**Sespe Creek Levee (SC-1)
Old Telegraph Road to Goodenough Road**

Evaluation Report

February 13, 2009

Sespe Creek Levee (Photo No. M13) – Vegetation & irrigation spigot within 15' of levee toe (Landward side)

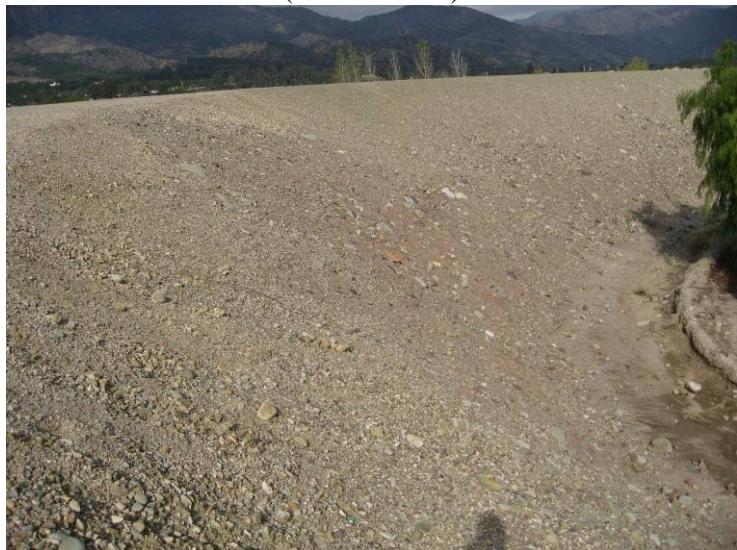
M13, M14, M15	Vegetation & Spigot on Levee embankment (Landward Side)	Remove vegetation and root ball, fill voids with impervious material and firmly compact.	C5 - PR issue with landowner (permitted)	E1	Landward veg removal not regulated	X	Spigot is from landowner and does not cross levee	Any irrigation, water or similar line located on or near a levee embankment that has the potential to cause erosion and failure of the embankment must be removed.
M16, M17	Undercut of Levee toe (Landward side)	Re-establish 2:1 toe of levee embankment. Additional engineering analyses are recommended.	C5 - Griffin Homes issue	E1	Landward repair not regulated	X	Can the dirt level be raised to the toe and regraded?	This repair will likely require design and engineering to cut, bench compact and possibly a retaining wall based on outcome of developer negotiations. Certified As-builts drawings need to be prepared.

**SECTION A****SECTION B****TYPICAL EROSION OR SURFICIAL SLOPE INSTABILITY REPAIR****LEVEE CERTIFICATION PROJECT
VENTURA COUNTY, CALIFORNIA**

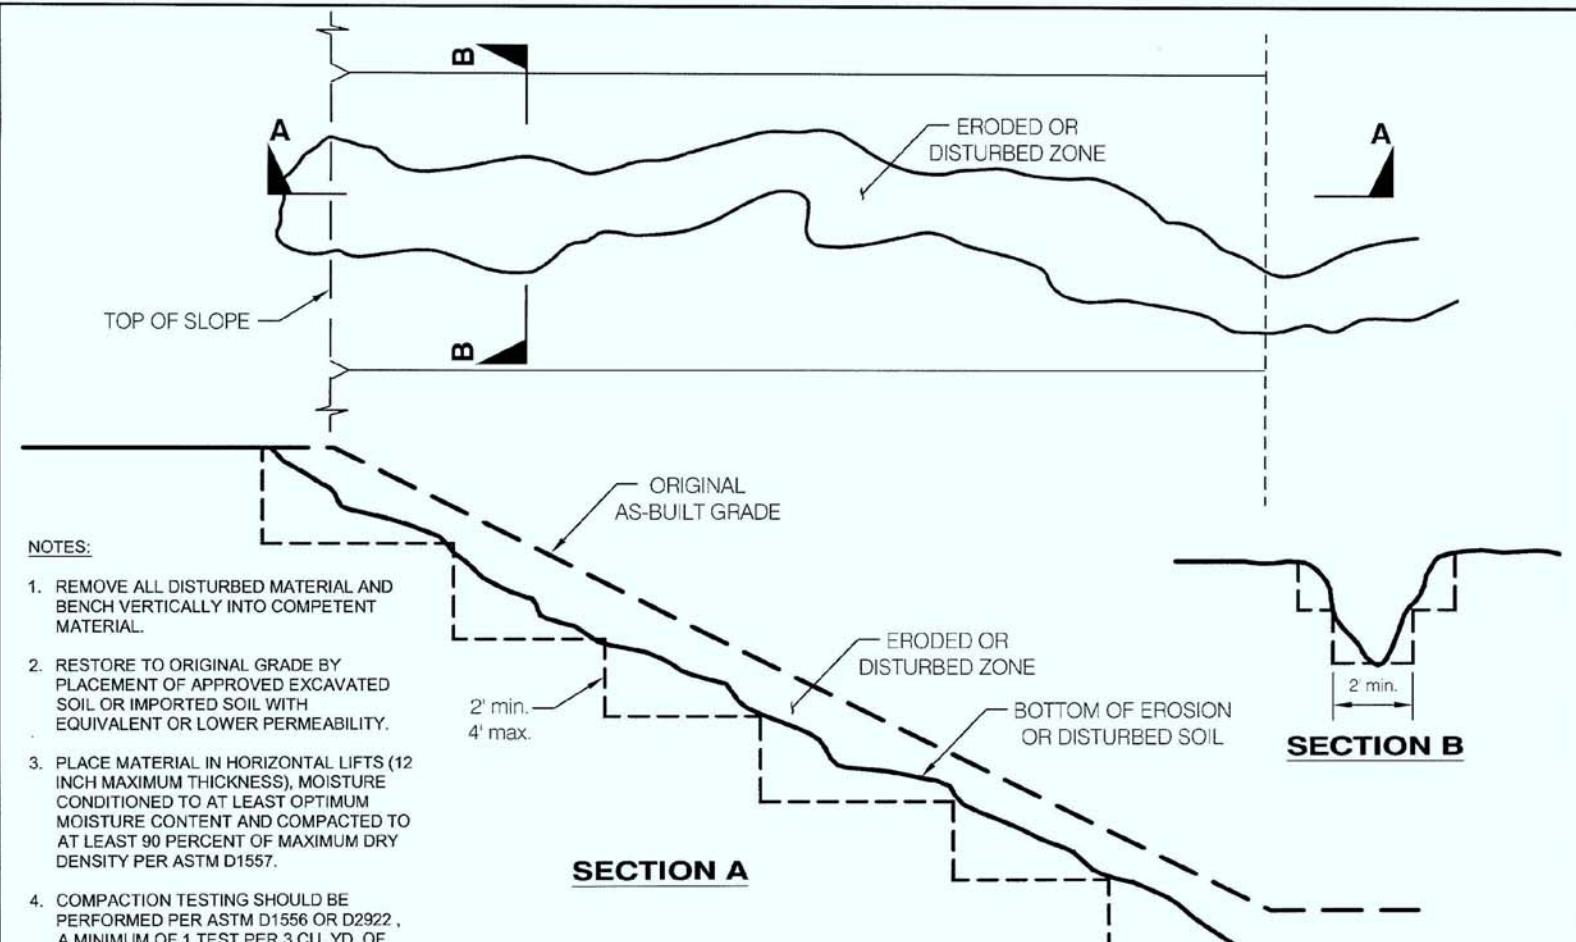
4. Can Tetra Tech provide specs for compaction and grading requirements? Discuss major and minor repair examples.	<p>Compaction requirements are detailed on the attached Figures 1 and 2. Major repair examples include any erosion feature that is deeper than 1 foot or that is greater than 2 feet wide. Major and minor animal burrows are discussed in item 1.</p>
